*Southern California Edison Company*

Subject: Docket Nos. 50-361 and 50-362  
San Onofre Nuclear Generating Station  
Units 2 and 3

RESPONSES TO NRC QUESTIONS  
SAN ONOFRE NUCLEAR GENERATING STATION  
UNITS 2 & 3

SEPTEMBER 3, 1980

Figure 121.21-1

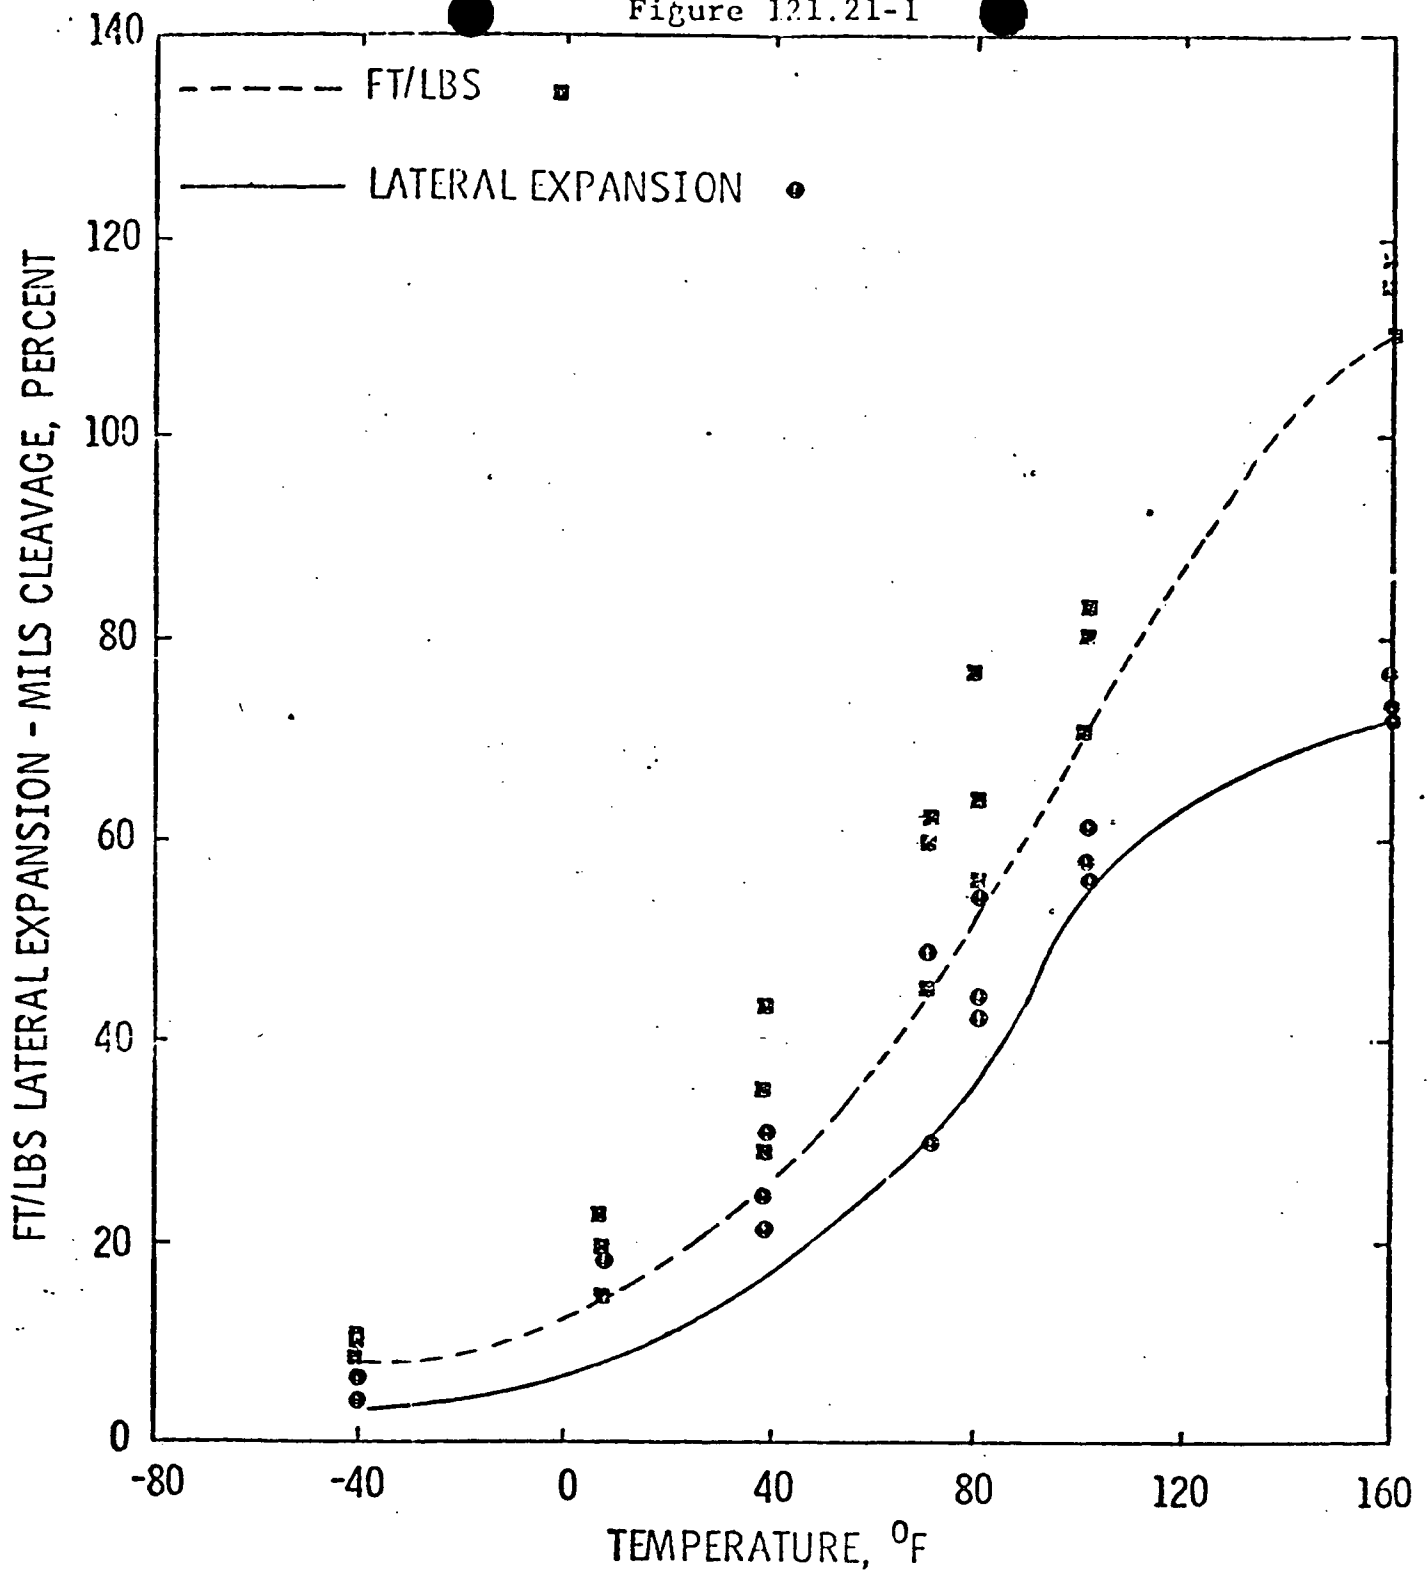
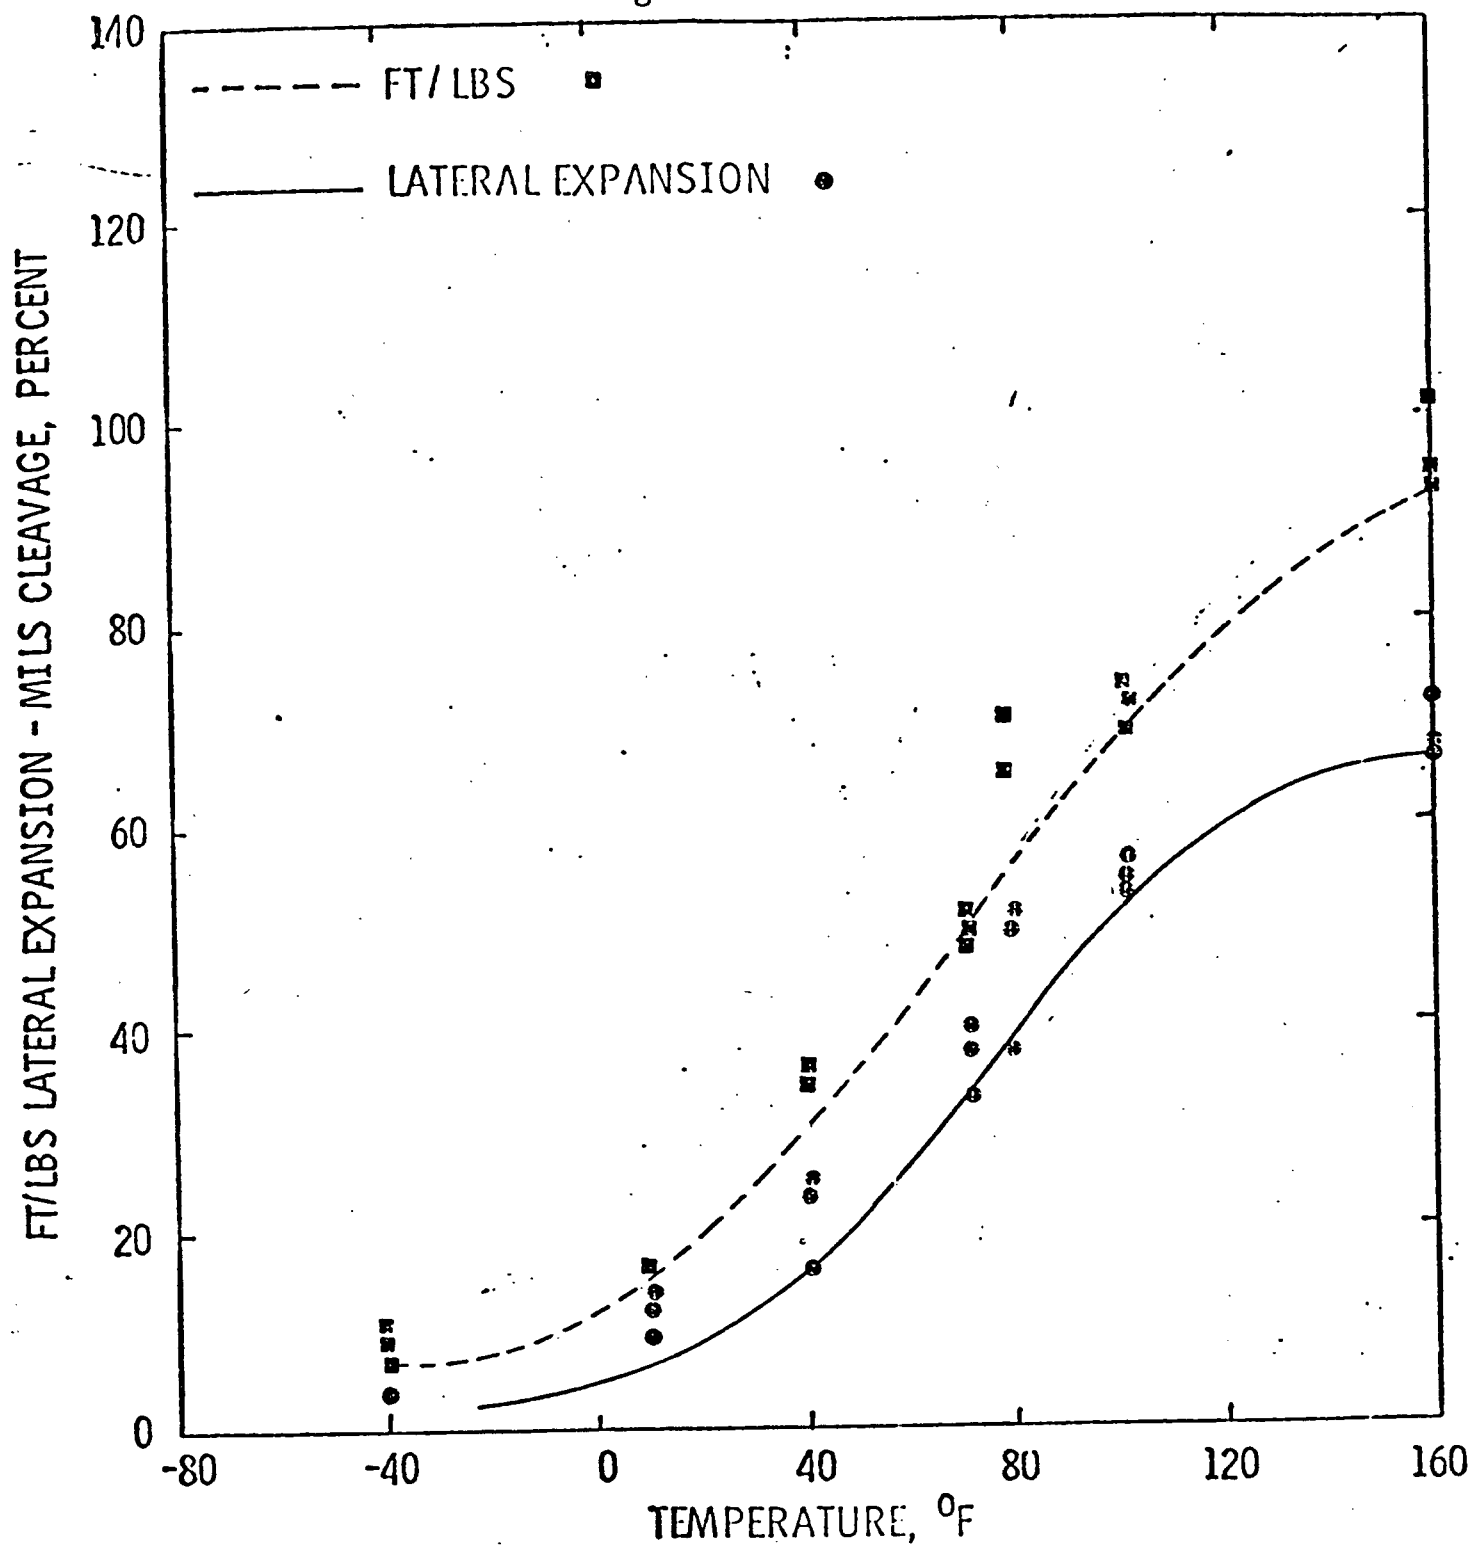
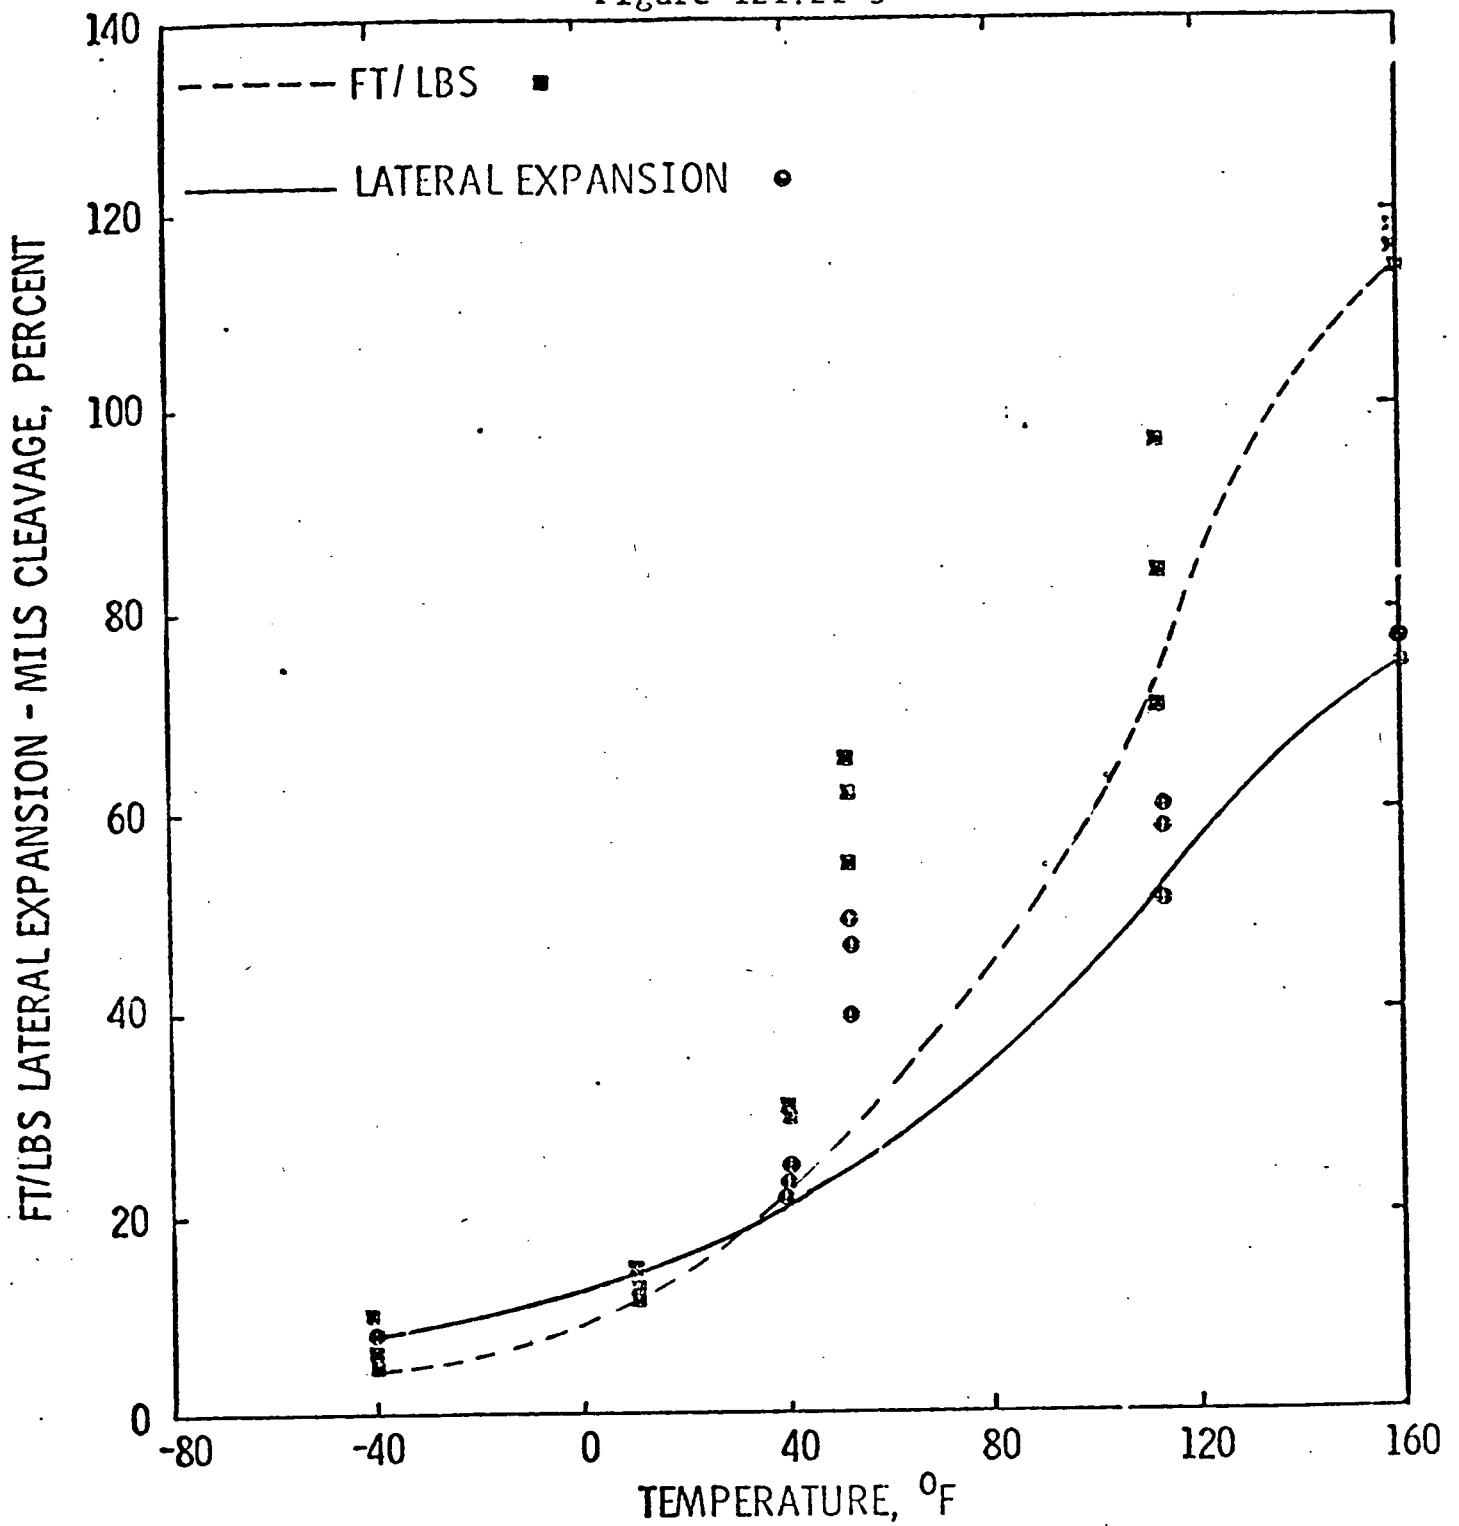
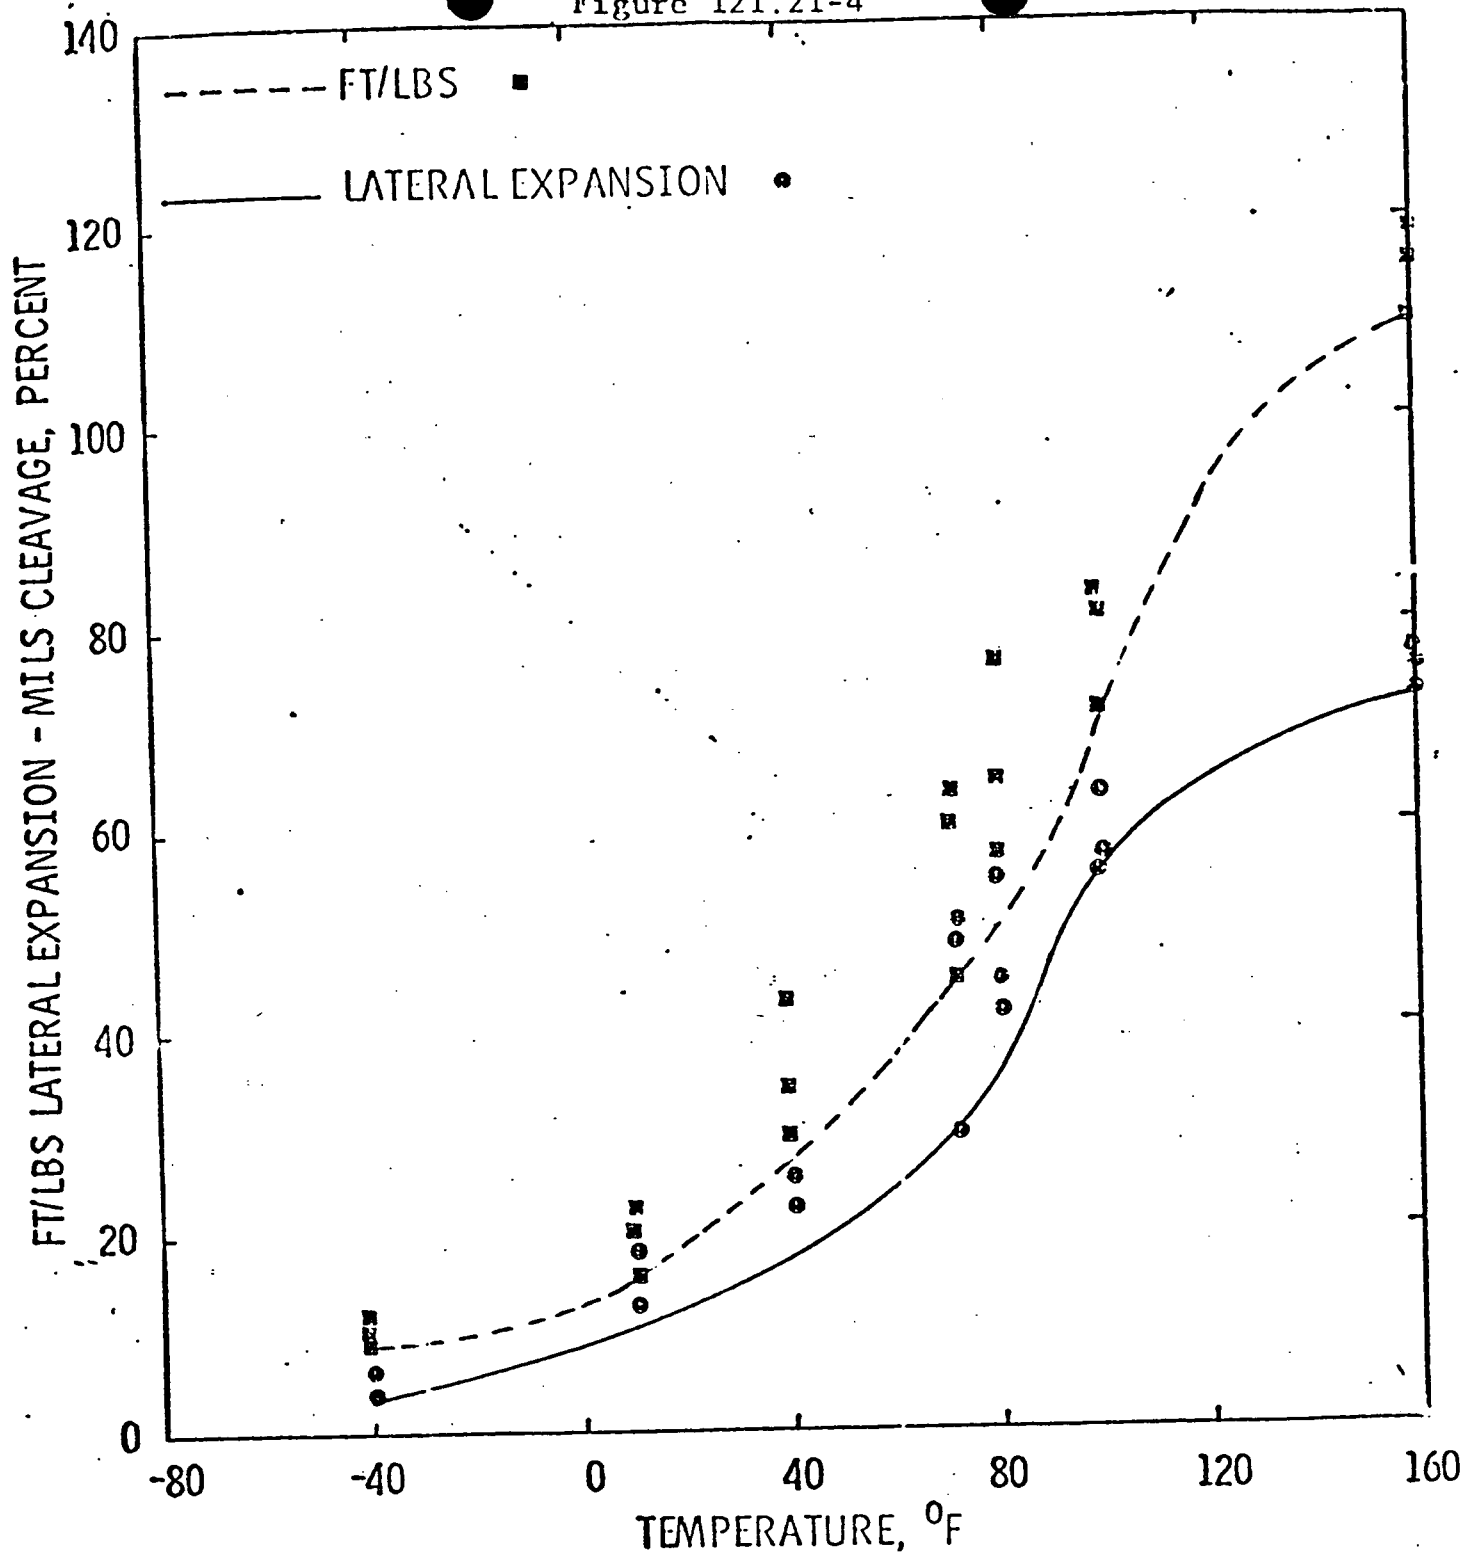
- (1) for the reactor vessel beltline materials, provide full Charpy V-notch curves, including data points, reported in impact energy and lateral expansion, both as a function of temperature;

- (1) Beltline materials Charpy test results for Units 2 and 3 are shown in Figures 121.21-1 through 121.21-12, respectively. The data points have been included. Tables 121.12-1 through 121.21-12 provide the data in tabular form corresponding to the Figures. The revised FSAR figures will be provided by 9/15/80 showing the Charpy test results.
